Form C-103
Revised July 18, 2013

SUNDRY NOTICES AND REPORTS ON WELLS
(DO NOT USE THIS FORM FOR PROPOSALS TO DRILL OR TO DEEPEN OR PLUG BACK TO A DIFFERENT RESERVOIR. USE "APPLICATION FOR PERMIT" (FORM C-101) FOR SUCH PROPOSALS.)

7. Lease Name or Unit Agreement Name: North Monument G/SA Un [302708]

8. Well Number: 006 (0306)

Schematic - Current

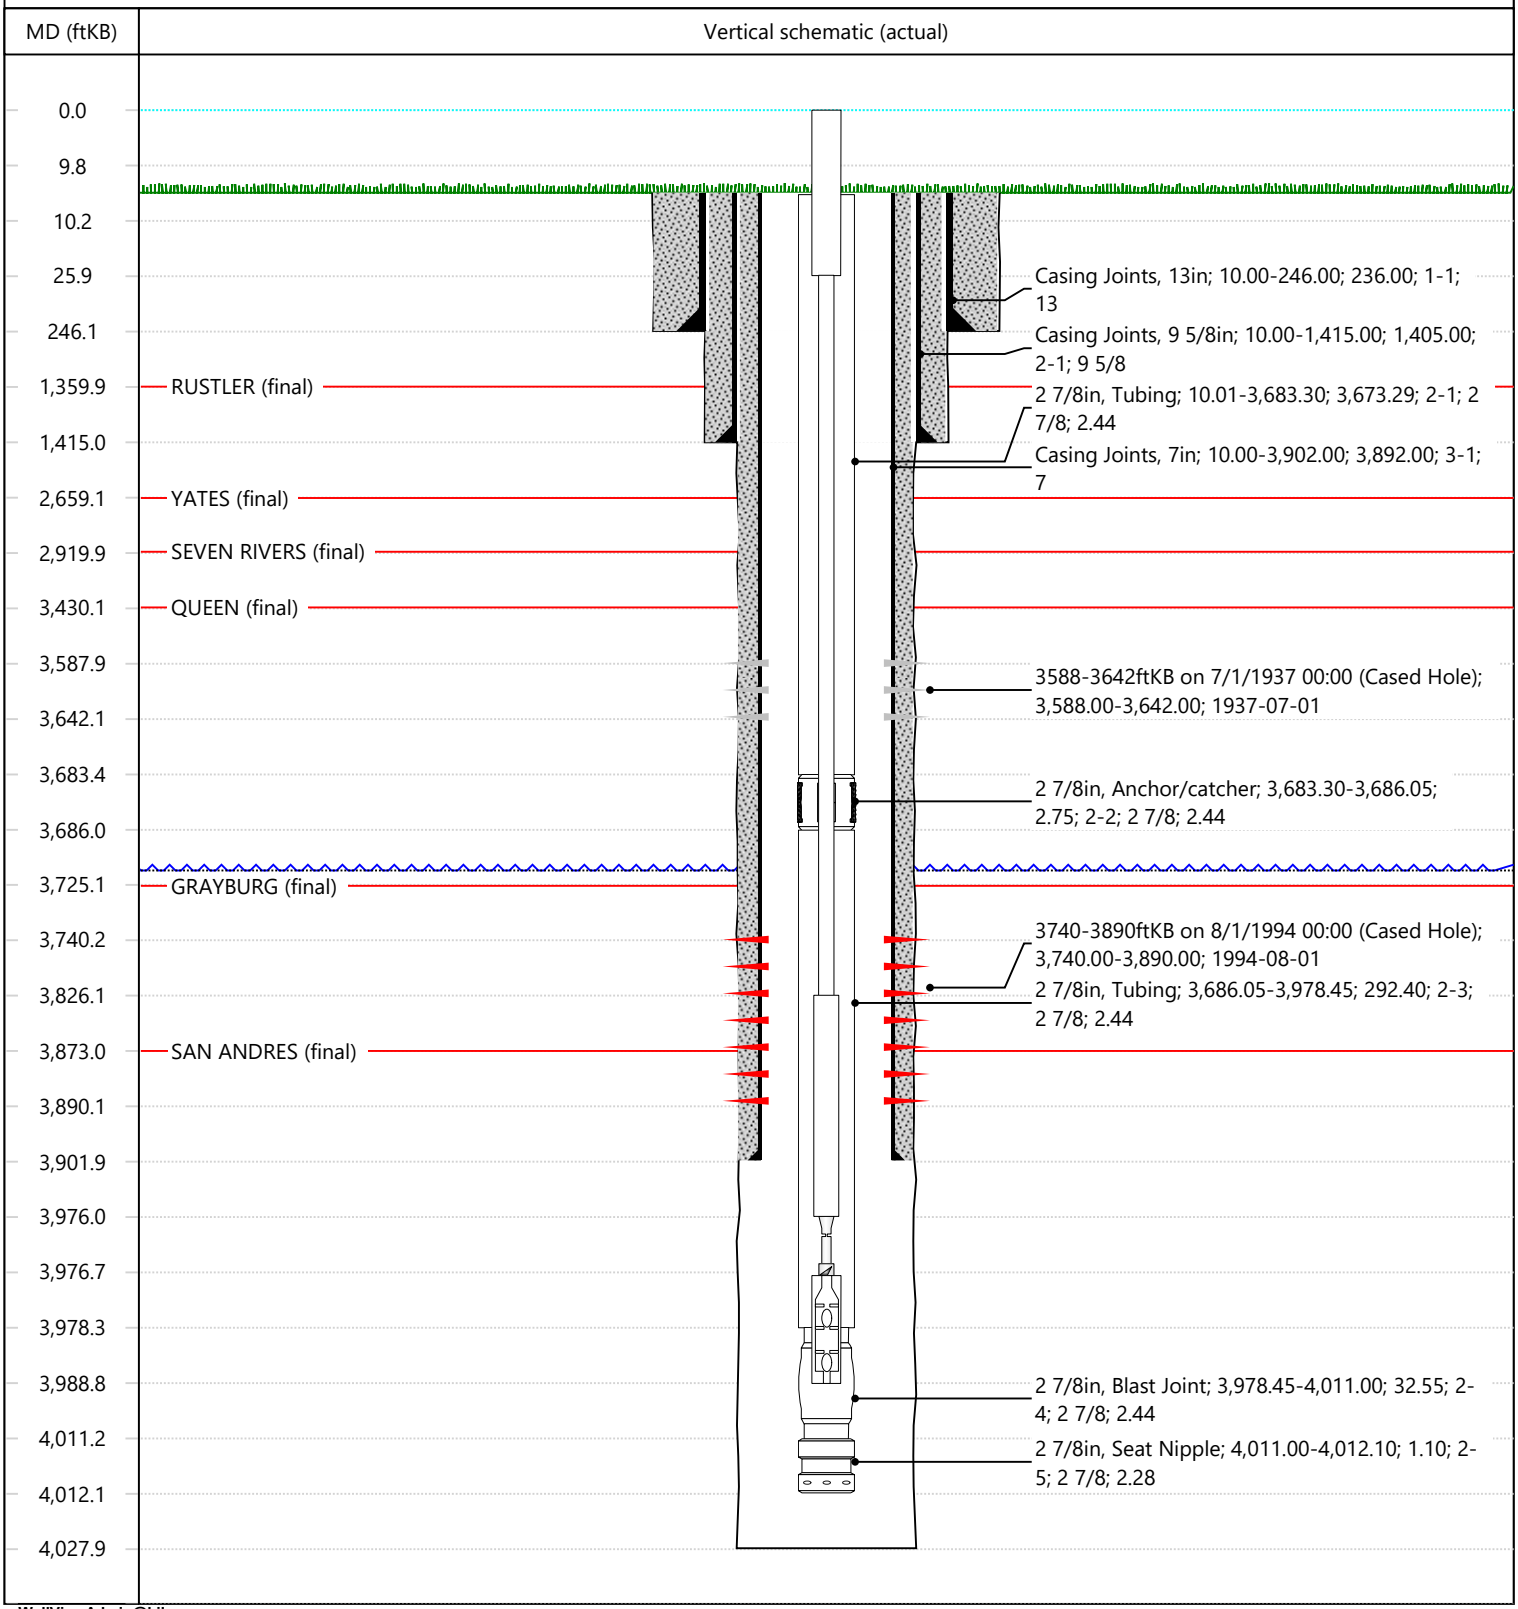
Hilcorp Energy is requesting permission to rig up on this well to perforate the current production zone, and then fracture stimulate the wellbore. The proposed perf interval is 3725' to 3902'. This interval is contained in the unitized GB/SA formation, but is not fully contained within the current perf interval (thus filing as a C-103E). The proposed procedure is outlined below. A current and proposed WBD are attached.

Schematic - Proposed

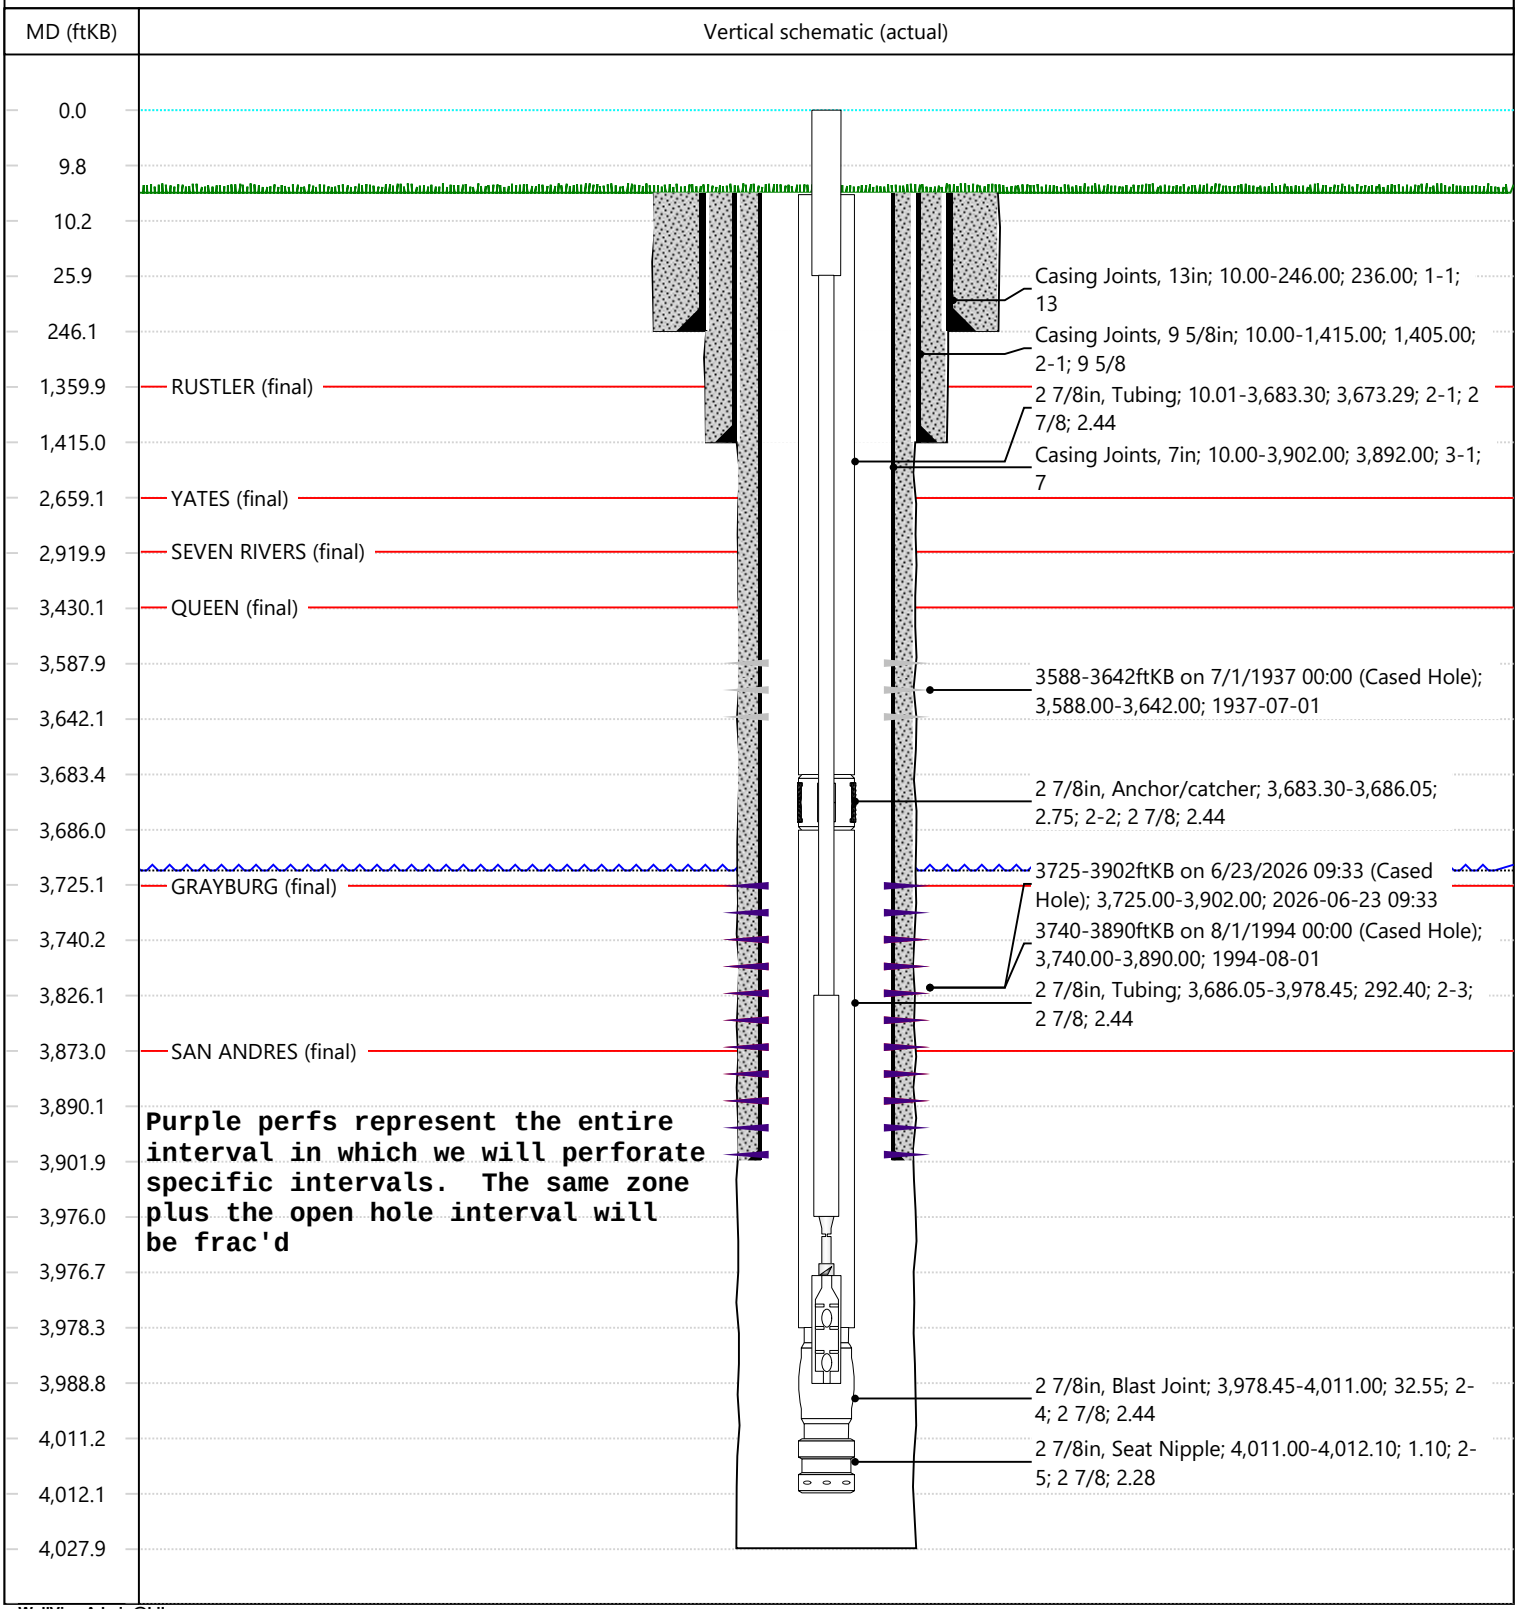
1. POOH with rods and production tubing.
2. RIH and perforate specific intervals within the unitized Grayburg formation (3725' to 3902').
3. RIH with workstring and fracture stimulate the Grayburg interval from 3725' - 4028'.
4. POOH with workstring and RIH with production tubing, anchor, rods and pump.
5. Put well back on production.

Created By	Condition	Condition Date
dmcclure	All conducted logs shall be submitted to the OCD as a [UF-WL] EP Well Log Submission (WellLog).	7/8/2026
dmcclure	If Cement is not adequate to protect casing and isolate strata: (a) the uppermost perforation in each additional pool to at least 150 feet above that perforation; and (b) the lowermost perforation in each added pool to at least 100 feet below that perforation, the appropriate Inspection supervisor shall be consulted and remedial action conducted as directed.	7/8/2026
